TO: Mountain Village Design Review Board

RE: Staff Memo – Initial Architecture and Site Review (IASR) Lot SS811, 2 Mountain Village Boulevard pursuant to CDC Section 17.4.11

APPLICATION OVERVIEW: New Single-Family Home on Lot SS811

SHEET NUMBER:
A104

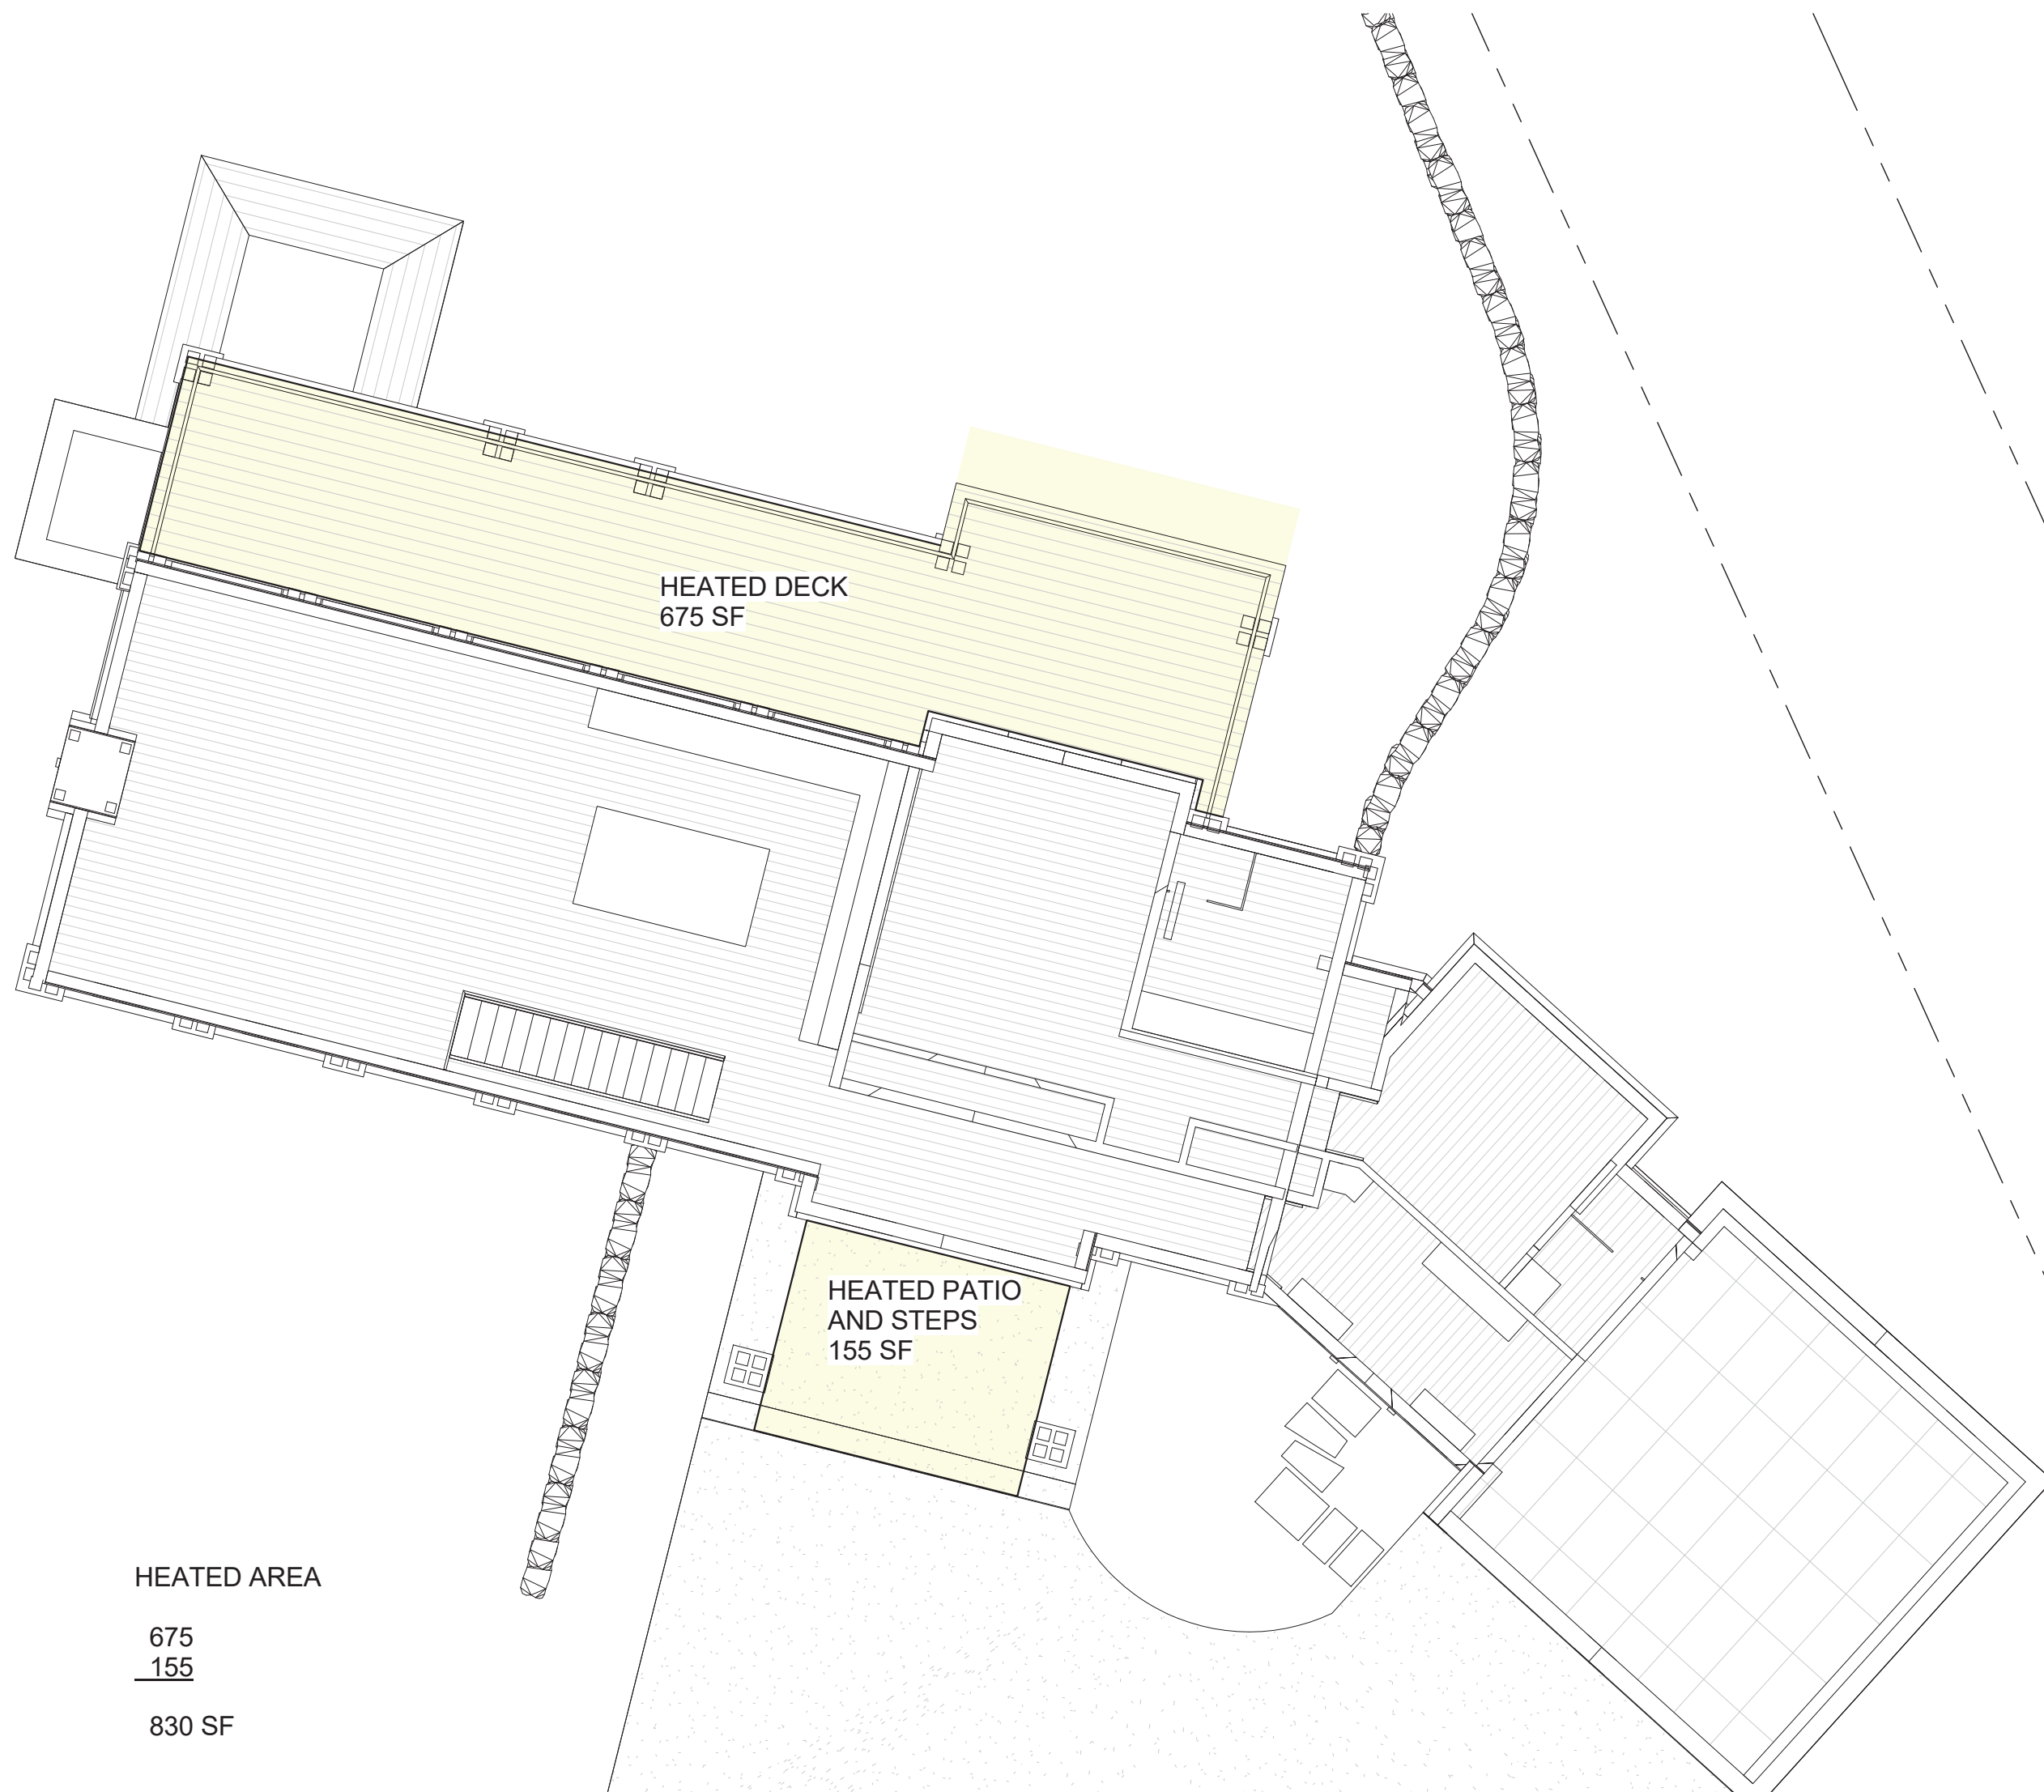
The location of these fixtures is proposed in the exterior lighting plan found on sheet A104 of Exhibit A. The lighting as proposed seems to meet the general lighting requirements of the CDC.

C3

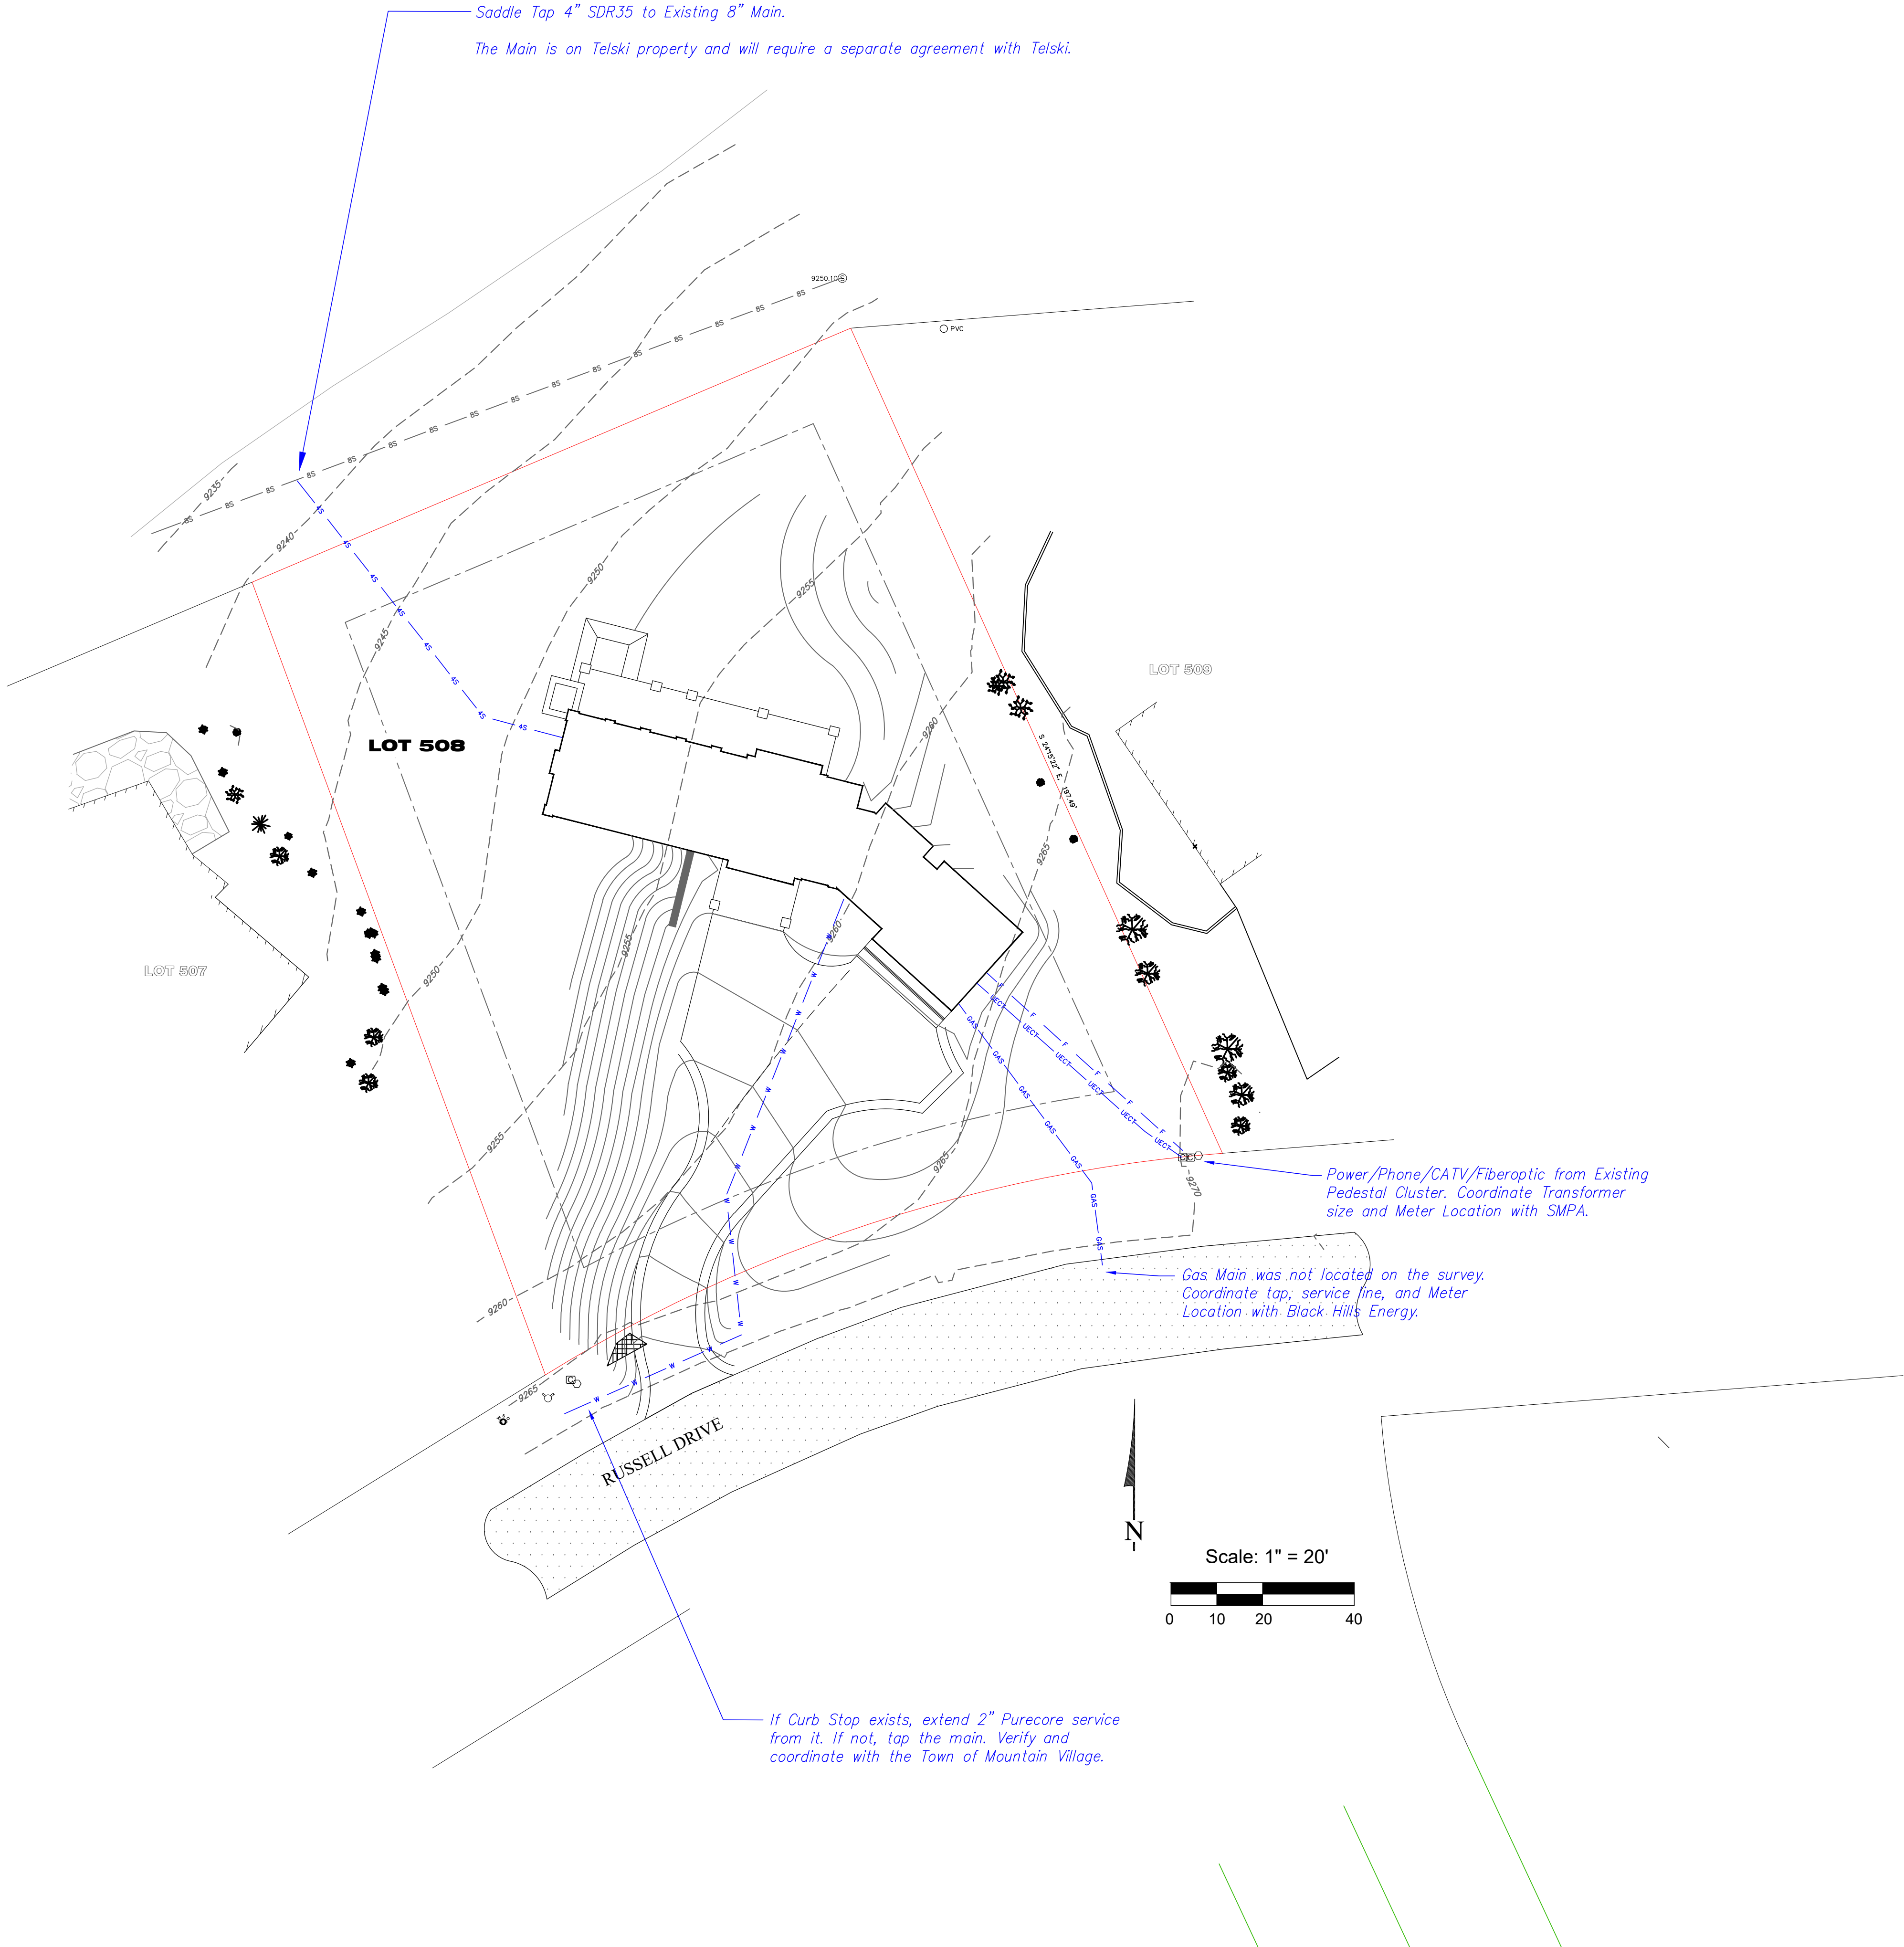
Staff: The utility plan is provided on sheet C3 of Exhibit A. The plan shows that the proposed gas and water lines will connect to the current lines on Mountain Village Boulevard and follow the driveway up to the structures. The water line seems to cross over a small portion of OSP-18.

The plan also indicates the placement of a new transformer on the lot located near the guest house with new electric lines that will connect to the proposed structures on the lot as well as to the transformer on the adjacent Lot 810-C to the east.

The plan shows a new sewage connection being proposed to the existing manhole located on the northwest corner of the lot. This sewer connection is located on OSP-18. It should be noted that any encroachments on OSP-18 for utilities will require an easement with the landowner.
